Staff Report

Item: DR 22-07 & EXCP 22-03 "Do It Best Expansion" at 333 S. Woodland Ave

Action on a Type III land use application package, Design Review DR 22-07 and Exception to Street Right of Way and Improvement Requirements ("Street Exception") EXCP 22-03.

Figure 3.01B – Major Arterial

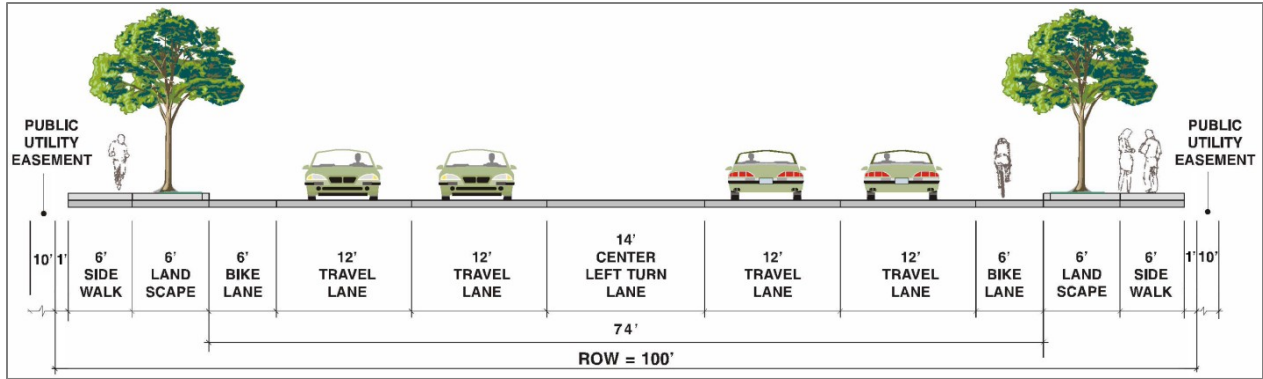
Improvements along the Newberg Hwy frontage do not include a landscape strip between curb and sidewalk, which does not conform with Figure 3.01B. Likewise, improvements along the S. Woodland Ave frontage do not include the landscape strip between curb and sidewalk, which does not conform with Figure 3.01E. The applicant applied for an Exception to Street Right-of-Way and Improvement Requirements (“Street Exception”) with a request to maintain the existing improvements. Staff addresses this request later under the analysis for 5.03.03.

Site plan excerpt with existing trees circled in green. The southerly two trees appear to be proposed for removal to accommodate parking lot improvements.

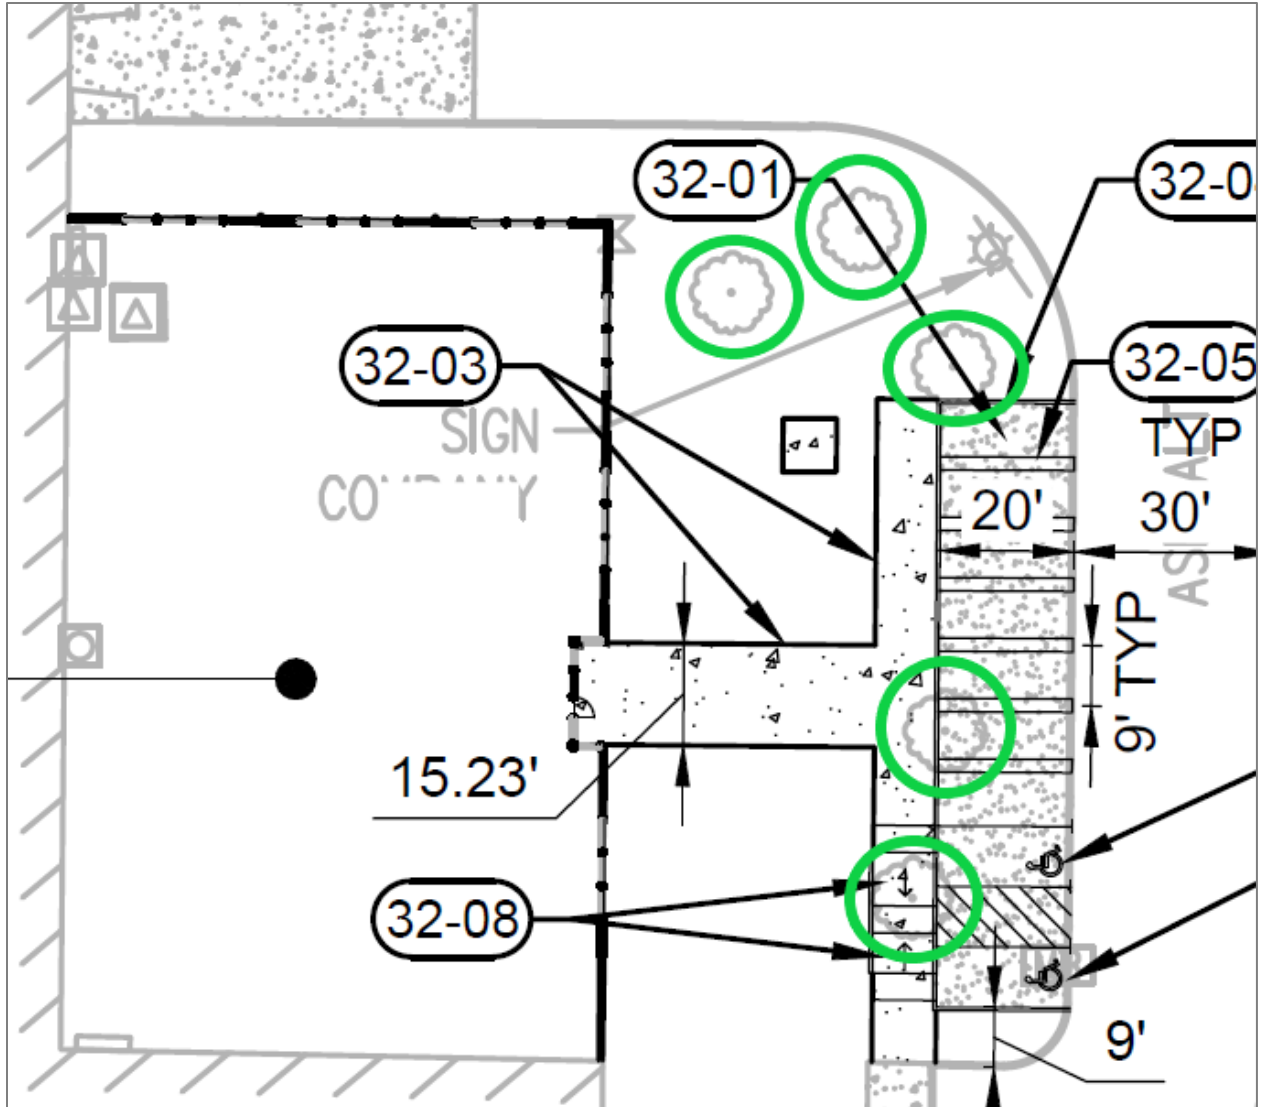
The submitted landscaping plans generally illustrate conformance with these provisions. There are five existing trees near the east office expansion area, two of which appear to be proposed for removal to accommodate additional parking area (see the image on the following page). Staff adds *Condition of Approval 7* to have the applicant make a reasonable effort to protect and preserve the other three existing trees throughout the construction process. The condition outlines a path for removal if preservation is not physically possible.

Google street view (photo from May 2019) showing the tree line along the corridor and gap in the foreground.

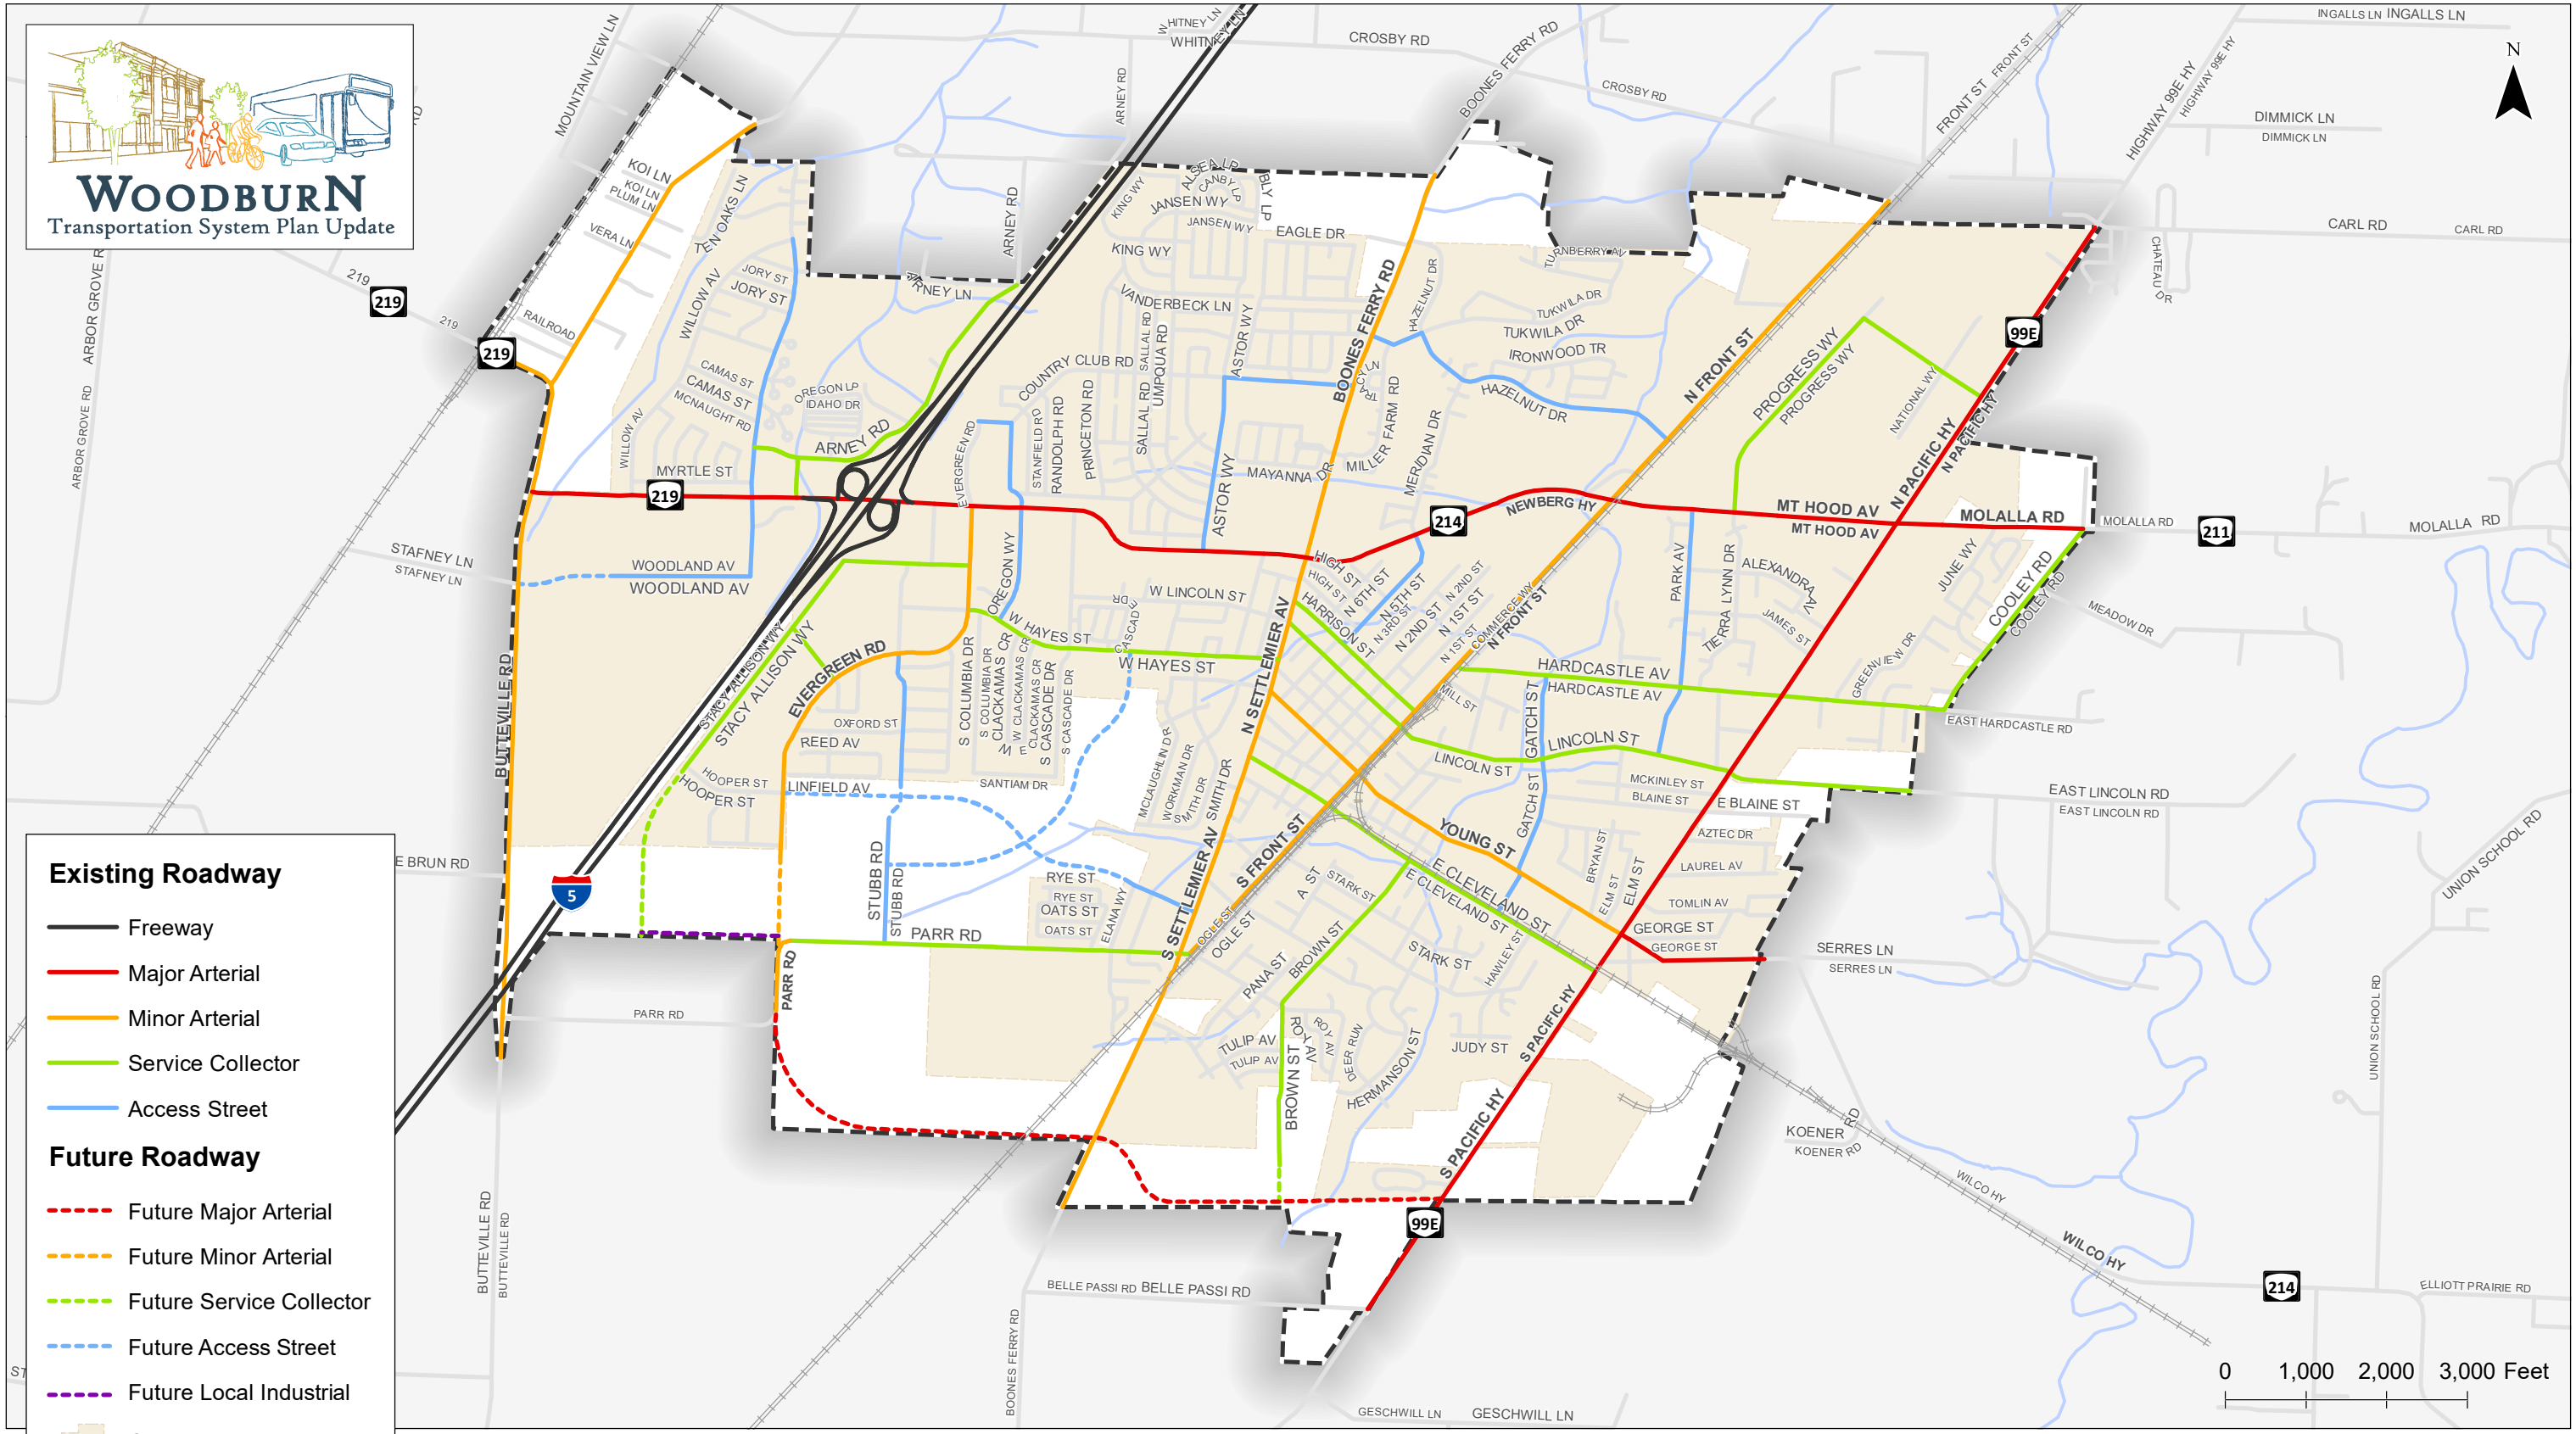
There is a gap in this tree line in the northeast corner of the property (between the intersection and the existing building). Looking at street view images from 2012 to 2019 on Google (see images on the following page), the gap appears to have been created due to the addition of an eastbound right turn lane along Newberg Hwy as part of the interchange project. Staff adds *Condition of Approval 8* to have the applicant fill the gap by continuing the tree line to the eastern extent of the paved trailer parking area.

8. Newberg Hwy Tree Line: The applicant shall revise landscaping plans to fill in the approximately 120-foot long gap in the tree line along Newberg Highway in the northeast corner of the property, between the existing tree line and the eastern boundary of the paved trailer parking area (see image below). Tree planting within this gap shall match the tree species and spacing illustrated on Sheet L1.10. Revised plans are due prior to building permit issuance.
